Docket Item # 3
BAR CASE # 2009-0205

BAR Meeting
October 7, 2009

ISSUE: Alterations
APPLICANT: Cameron Mews Ltd. Homeowners Association
LOCATION: 125 Cameron Mews
ZONE: RM / Residential

Figure 1. Cameron Mews site plan indicating proposed location of brick wall.

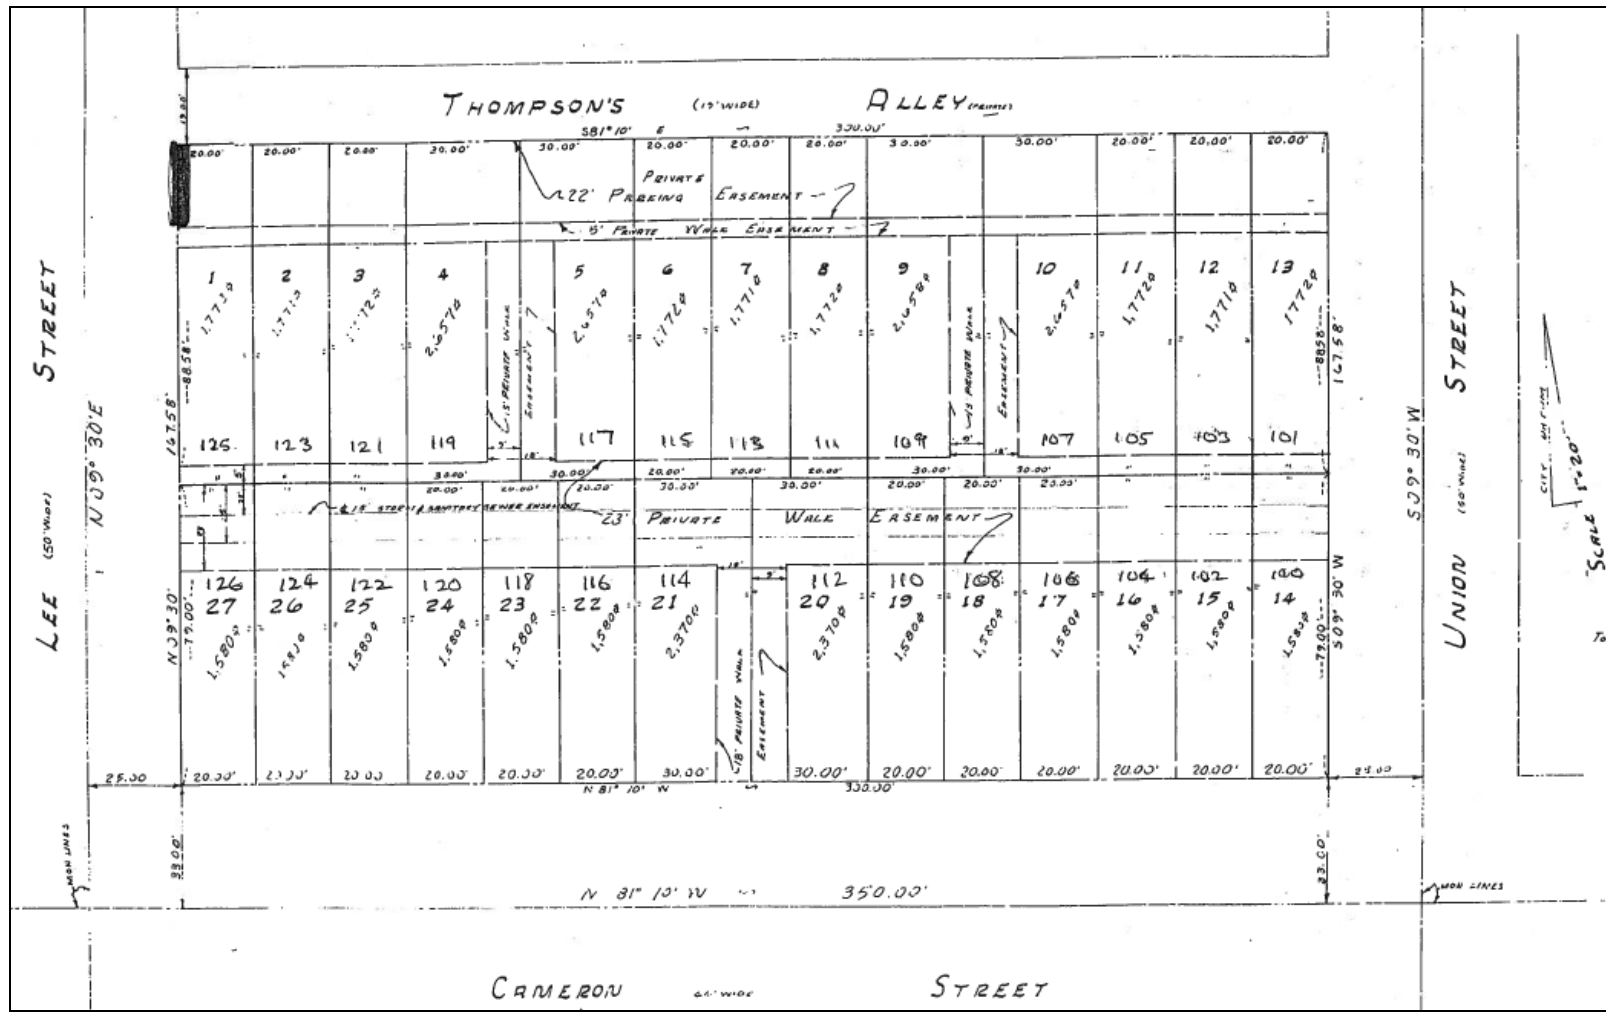
The applicant must show the location of the proposed wall on a survey plat to confirm compliance with zoning. To comply with the zoning ordinance and the development site plan, the proposed wall cannot encroach on the public right-of-way and cannot eliminate any of the required number of parking spaces, and parking spaces cannot be reduced to less than nine feet in width.

1. That the applicant submit a survey plat as part of the building permit application to Code Administration showing the location of the brick wall to illustrate that it will be located entirely on private property and not encroach into the public right-of-way; that it will not reduce the number of parking spaces nor reduce the width of any existing parking space to less than nine feet; and that a revised survey plat be submitted for final approval upon completion of wall construction.

Figure 4. Site plan of parking area with proposed wall.

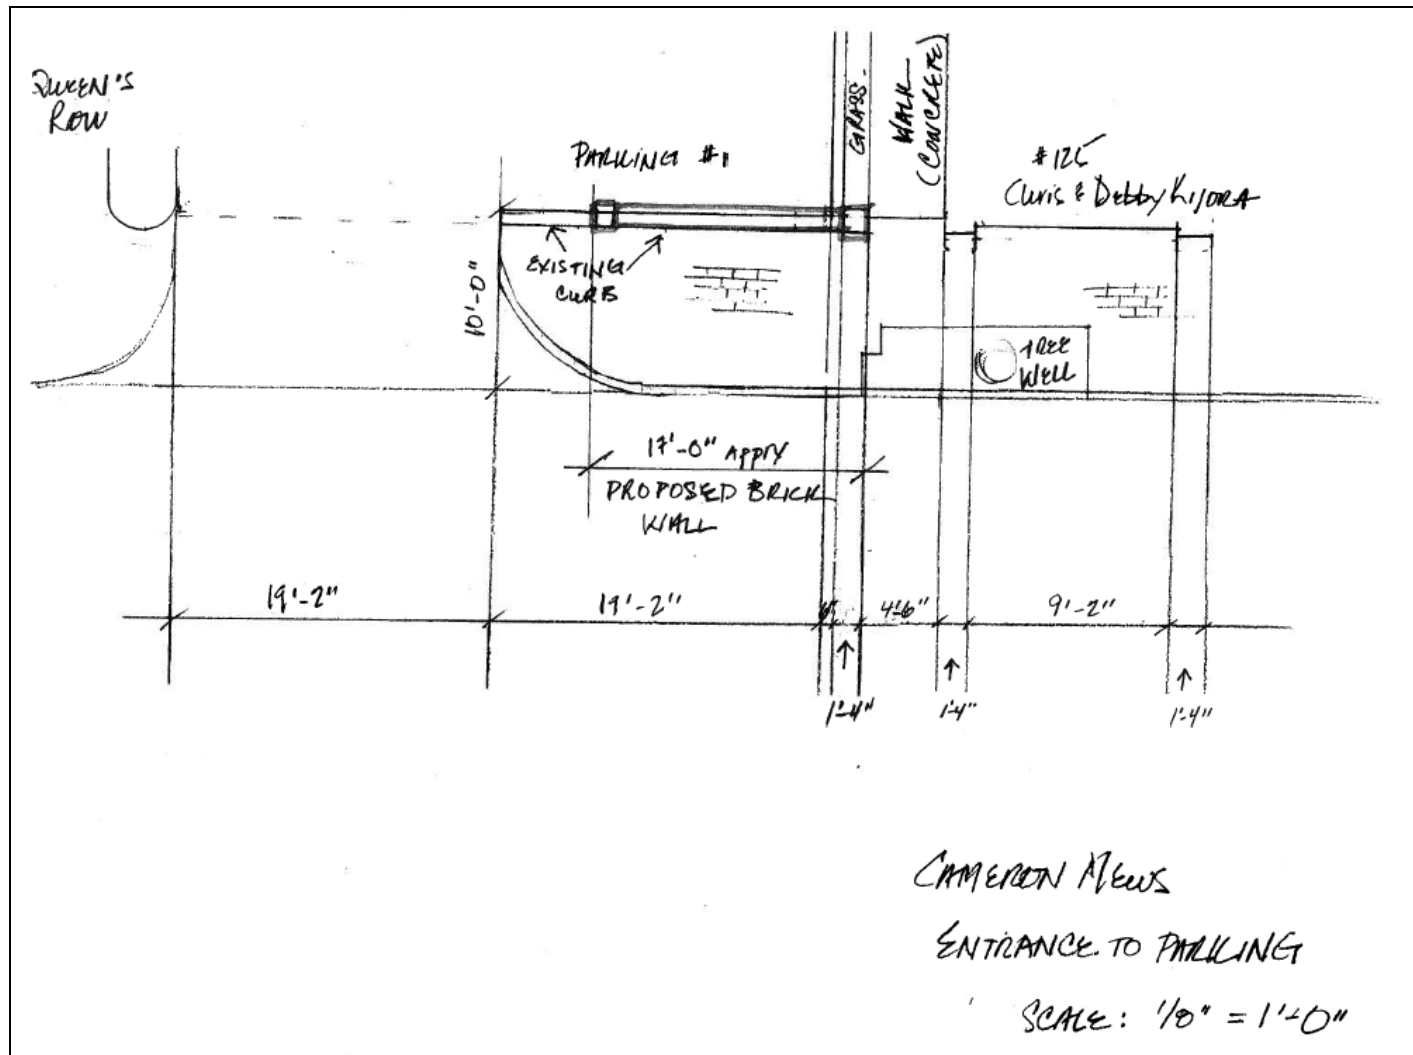
C-1 Requires a survey plat for final approval.

Figure 5. Proposed wall in elevation and plan.

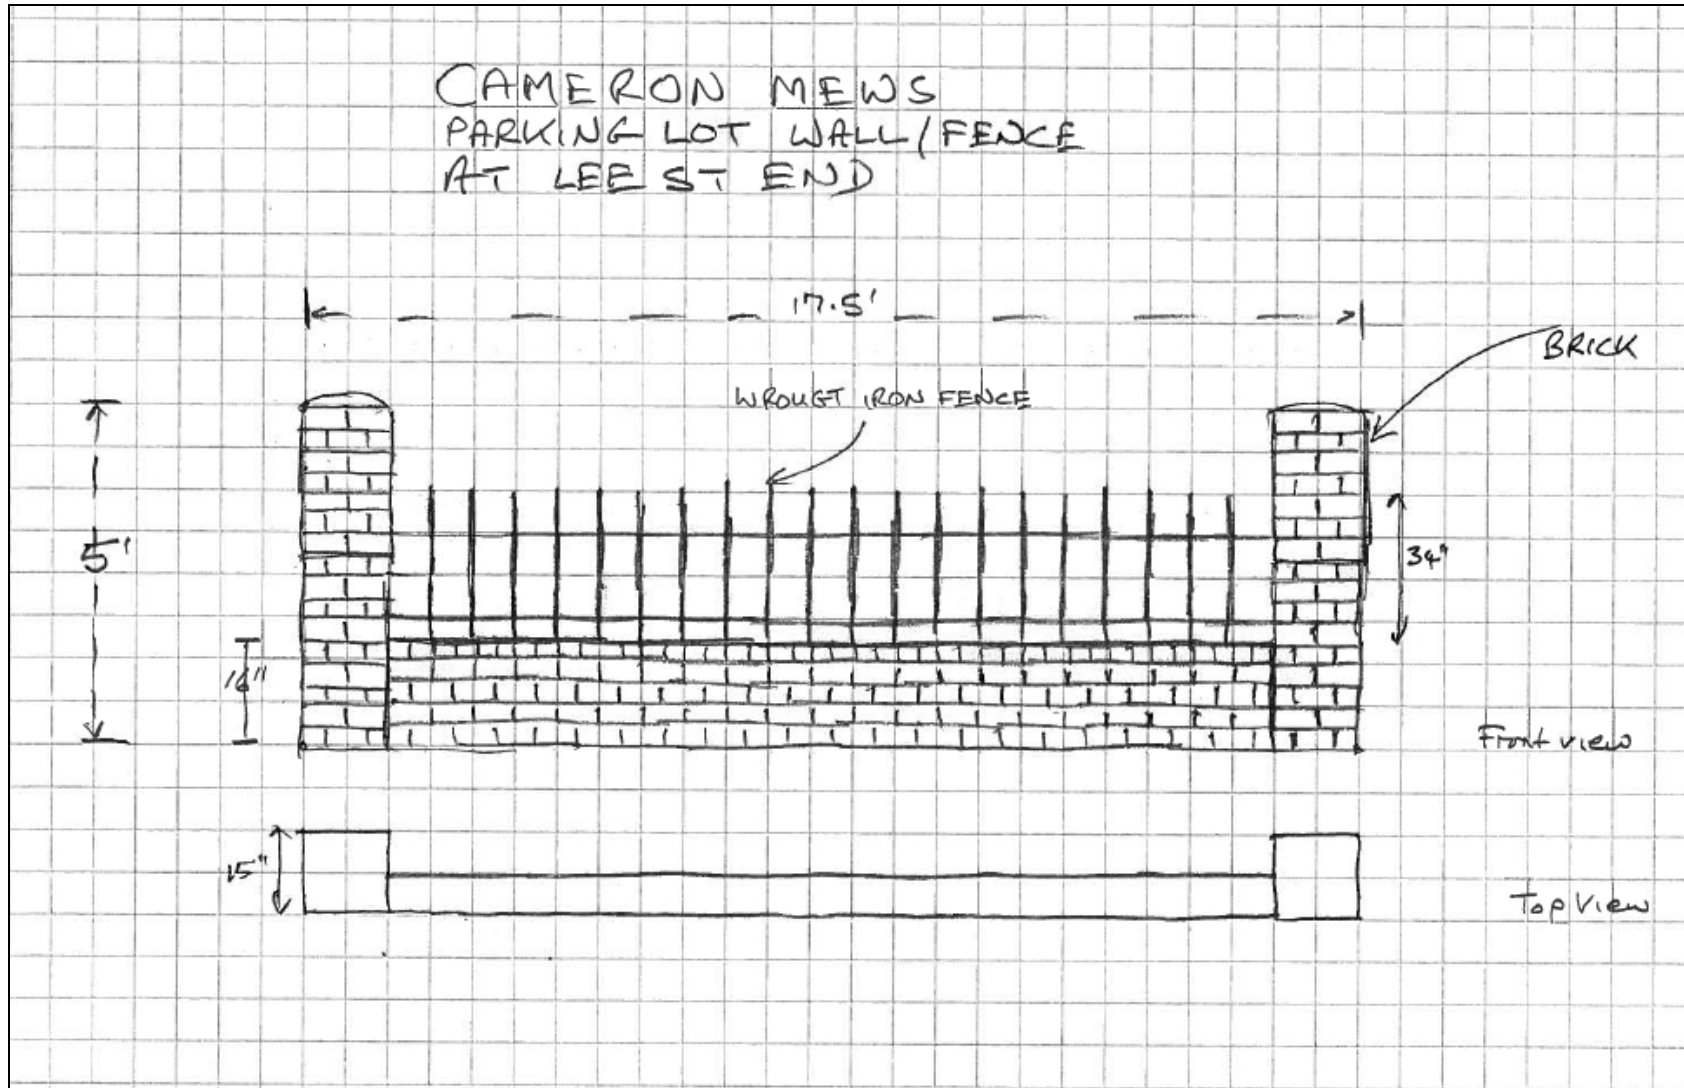
The proposed wall is brick and iron: brick piers and a brick base with inset iron fencing. This wall is proposed to match the existing wall at 125 Cameron Mews. The height of the brick piers will be five feet, the height of the brick base will be 16 inches and the iron fence portion will be 34 inches in height. The total length of the proposed wall will be 17.5 feet. The brick piers will be square and will measure 15 inches on each side.

Furthermore, the *Guidelines* state that “masonry fences and walls of brick are generally appropriate throughout the historic districts.” Staff finds that the design of the proposed wall is compatible with the surrounding area and will be a welcome addition to screen a row of existing parking spaces from North Lee Street. Staff recommends approval with the condition outlined below.
